Upper Seagry – Commercial

FRA Addendum 3 (January 2026)

Latest Response from LPA (25th November 2025)

Figure 1 – Access and Egress Routes

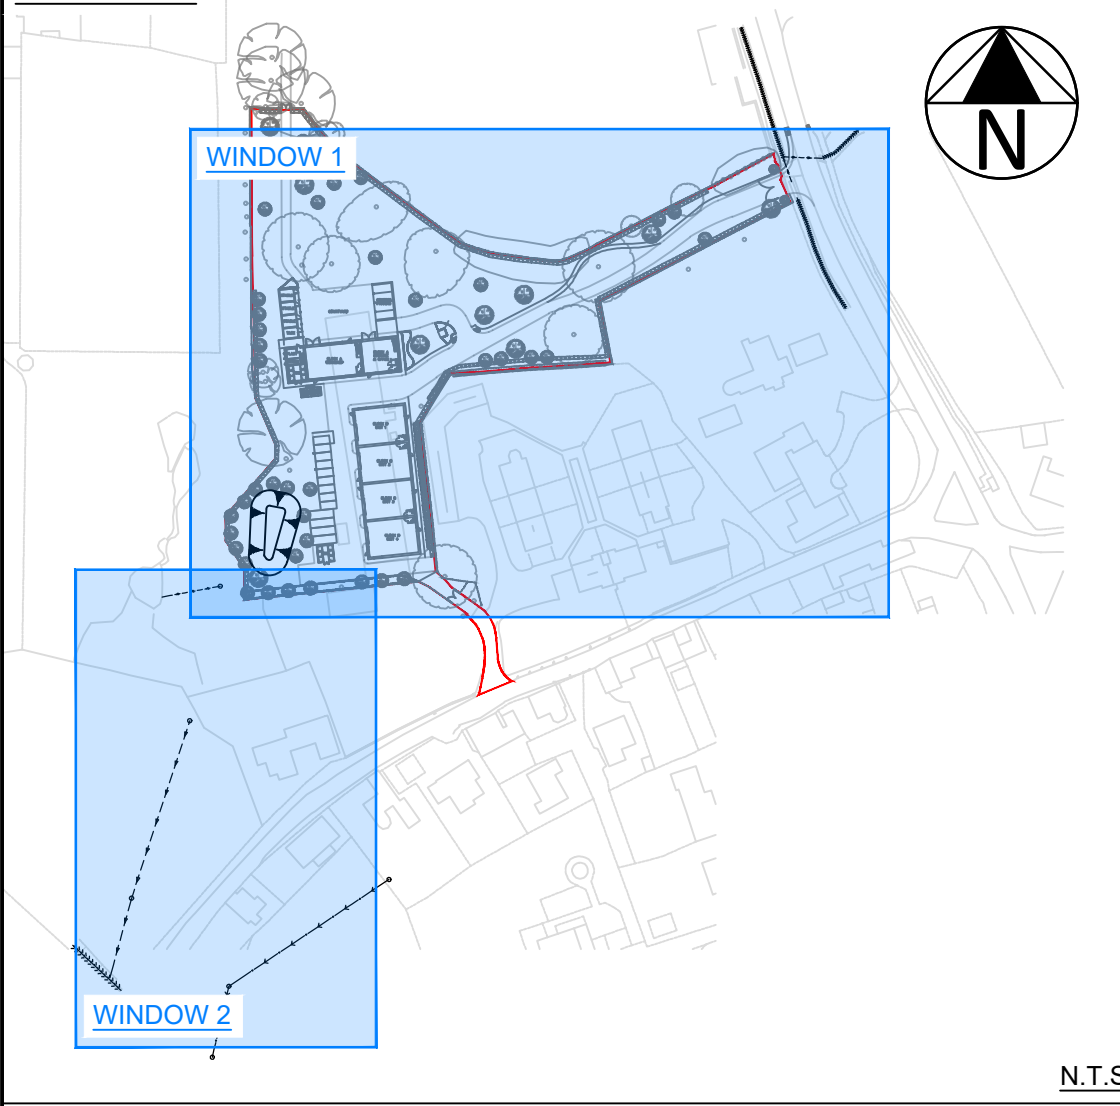
The LLFA have noted that the access to the site is predicted to be affected by surface water flooding, and that in line with the NPPF, an emergency plan would need to be agreed with WC.

As per SFRA, one of the proposed access routes to Startley Road lies within an area of surface water flood risk. However, a second access route via Henn Lane, outside the surface water flood extents, is proposed to function as an emergency access route. This ensures that safe access and egress can be maintained during flood events. Given that one of the access routes is susceptible to flooding, the applicant should prepare and provide an emergency evacuation plan, even if an alternative access exists. This plan should be agreed upon with Wiltshire Council to ensure clarity and preparedness in case of an emergency.

As noted in the November 2025 FRA Addendum, the site has two alternative access and egress routes which are unaffected by flood risk. The first route connects the proposed development to Henn Lane which is intended as an emergency access. The second route passes along the existing track to the north along the front of Seagry House. These routes are illustrated in **Figure 1** included below.

If required, an emergency access management plan can be provided for the proposed development via the discharge of an appropriately worded planning condition.

PDL-01

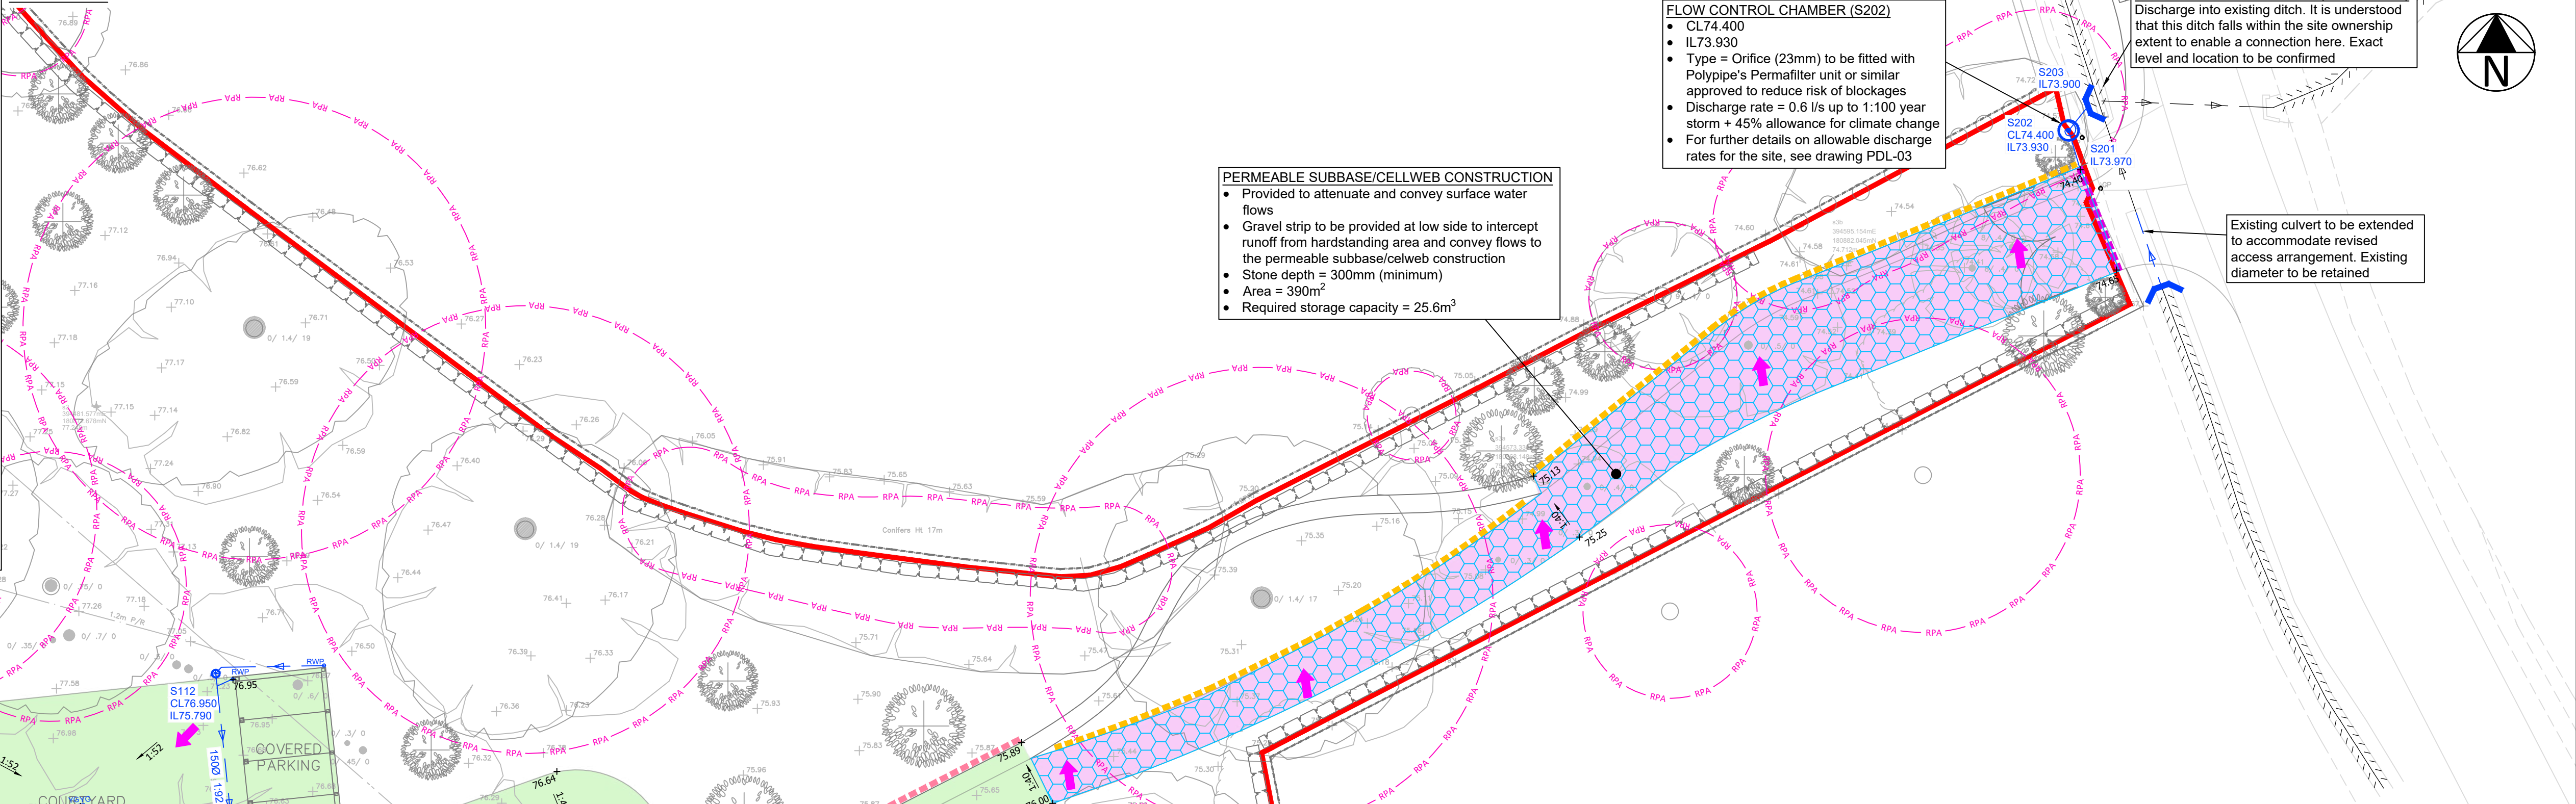
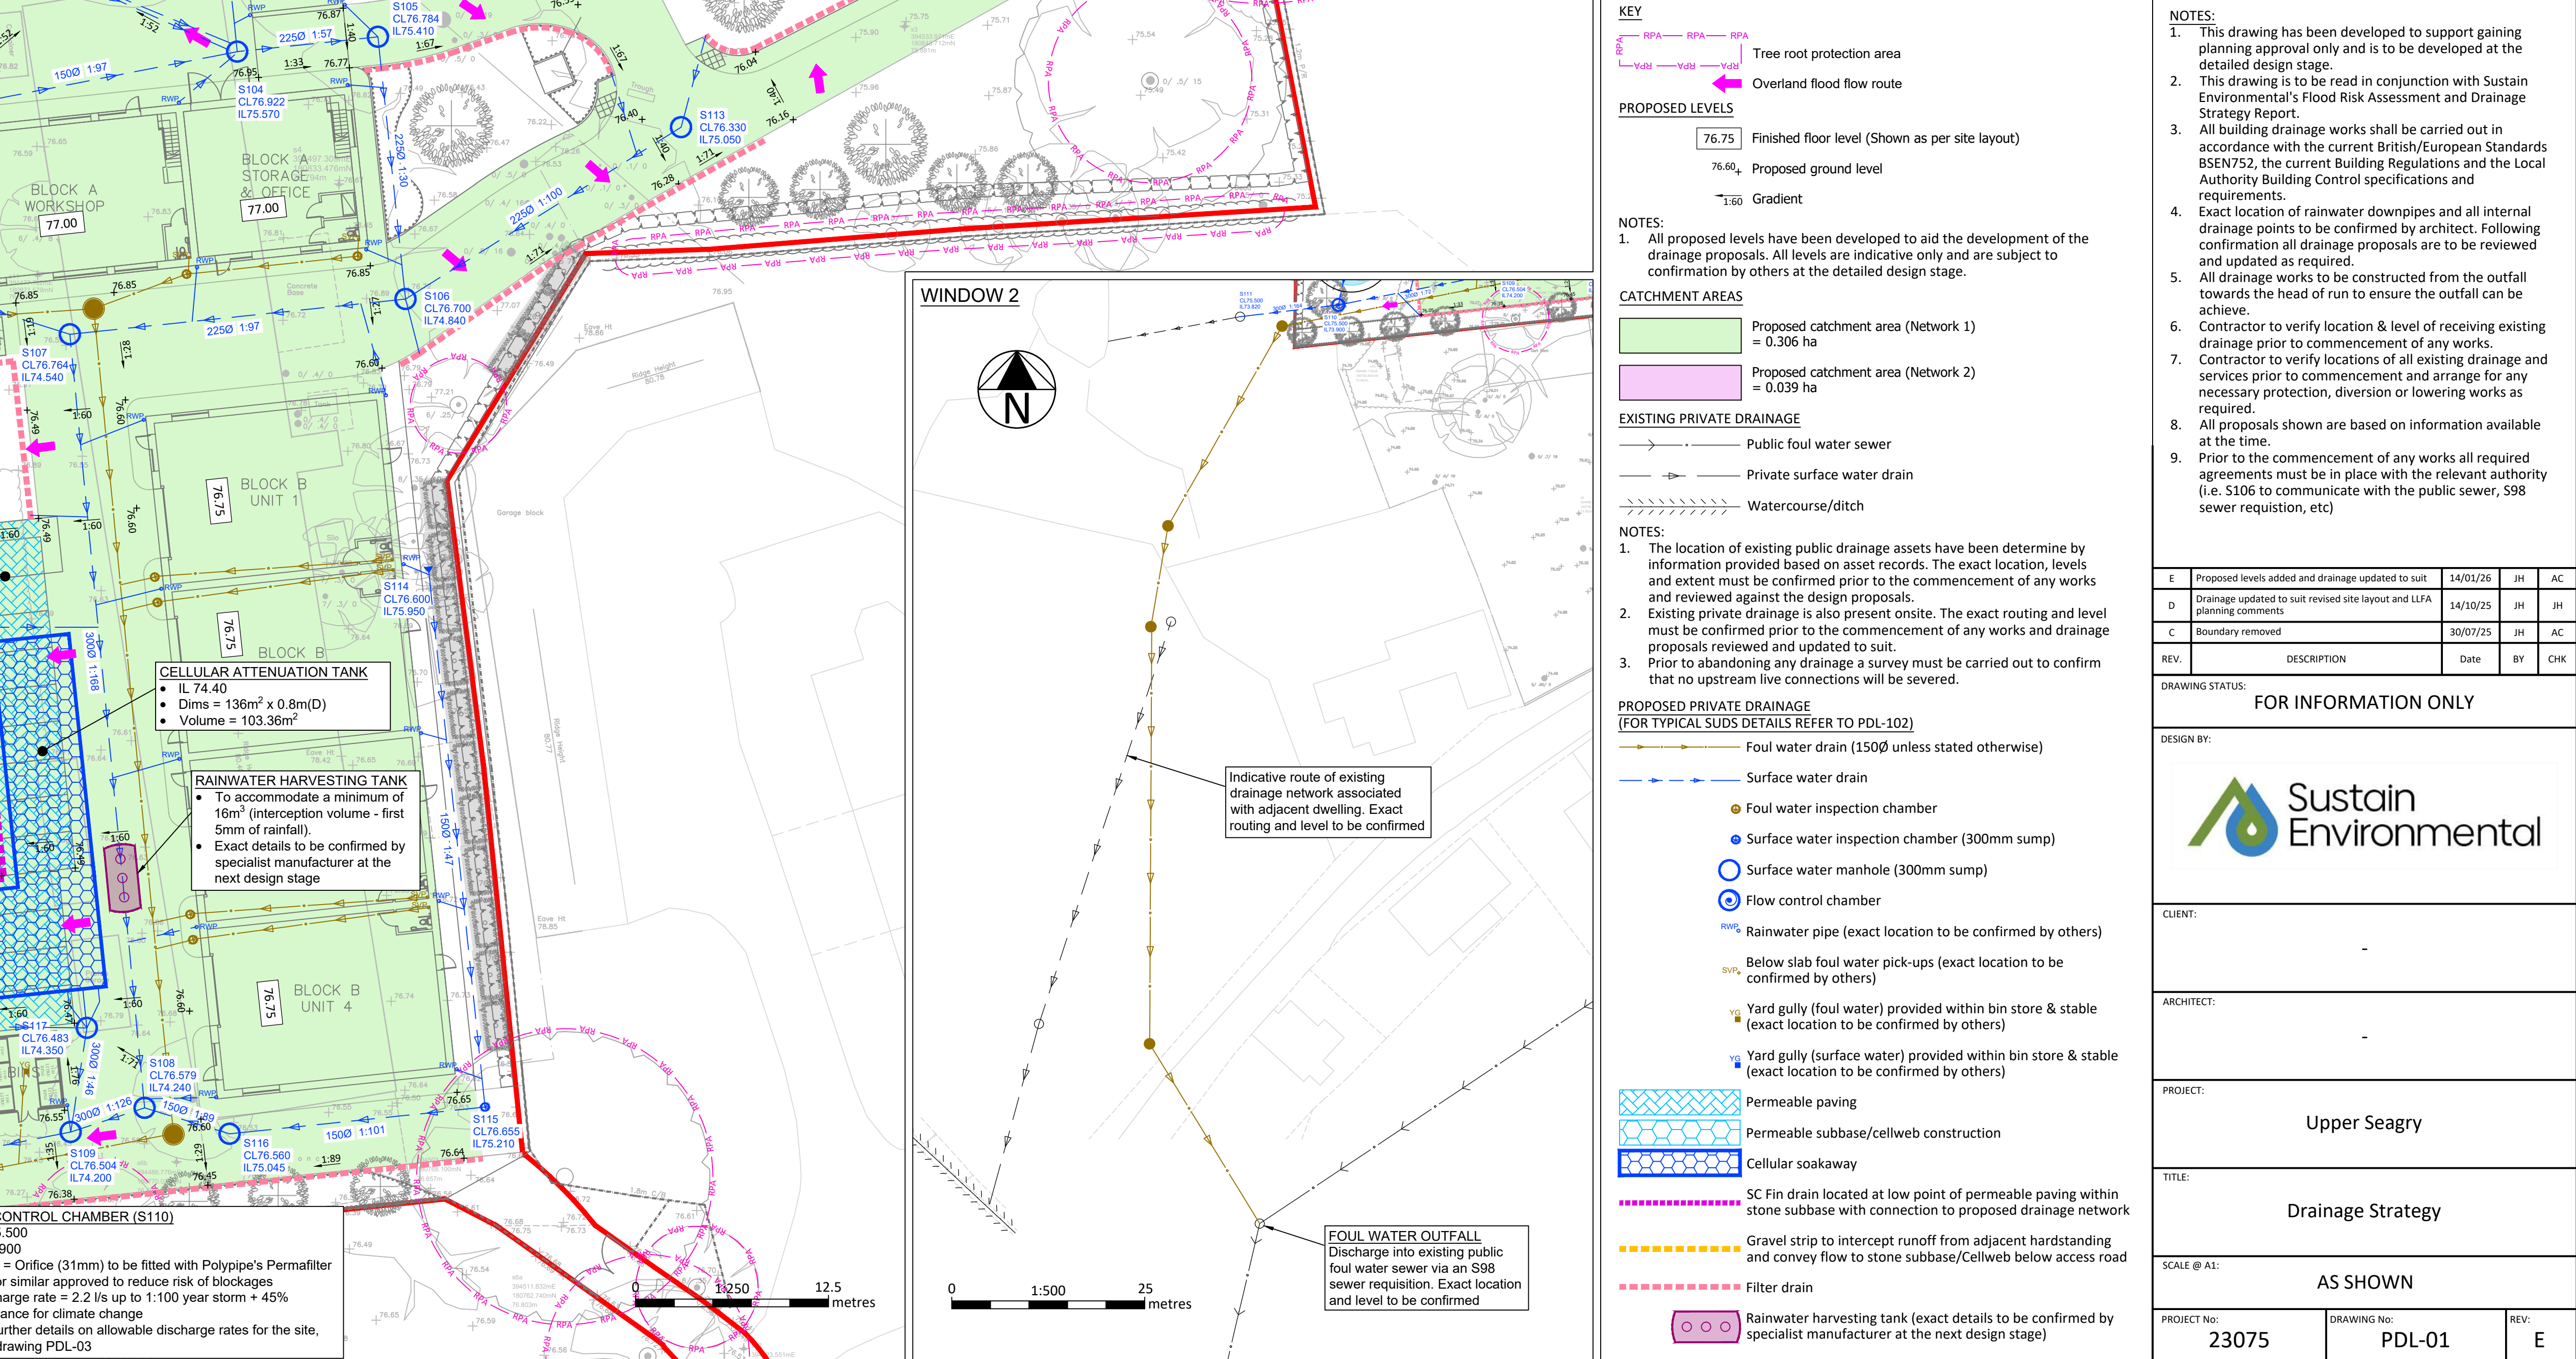
- *The submitted exceedance flow routing does not match the levels shown on the topographic survey in all locations. The applicant should confirm whether any re-levelling is planned to facilitate exceedance routing and submit any supporting topographical map for the proposed ground levels where required.*
- *The access to the site is predicted to flood, therefore in line with the National Planning Policy Framework, an emergency plan needs to be agreed with Wiltshire Council.*
- *With regards the control of surface water discharges from brownfield sites, Wiltshire Council requires post development discharges to be as close as reasonably practicable to greenfield runoff for both peak flow and volume.*

The applicant needs to confirm whether any ground re-levelling is required to enable the proposed exceedance flow routing, as the drainage plan only shows arrows denoting exceedance flow route without any proposed grading details.

- The submitted exceedance flow routing does not match the levels shown on the topographic survey in all locations. The applicant should confirm whether any re-levelling is planned to facilitate exceedance routing and submit any supporting topographical map for the proposed ground levels where required.
- The access to the site is predicted to flood, therefore in line with the National Planning Policy Framework, an emergency plan needs to be

The latest drainage strategy plan is included in **Appendix B** as **Figure PDL-01**, with this including the post-development site levels. As with the previous drainage strategy, the site is separated into two drainage catchments; the western catchment (Network 1) and the eastern catchment (Network 2).

The post-development overland flow routes are included in **Appendix B** on **Figure PDL-01**. This demonstrates that these flow routes all drain to areas where they would be intercepted and therefore managed by features proposed as part of the drainage strategy.

In response to the comment from the LLFA, this drainage strategy plan now shows the proposed ground levels and the post-development overland flow routes. This therefore addresses the comment on whether this matches the topographic survey and whether any re-levelling is planned to facilitate exceedance routing.

E	Proposed levels added and drainage updated to suit	14/01/26	JH	AC
D	Drainage updated to suit revised site layout and LLFA planning comments	14/10/25	JH	JH
C	Boundary removed	30/07/25	JH	AC
REV.	DESCRIPTION	Date	BY	CHK
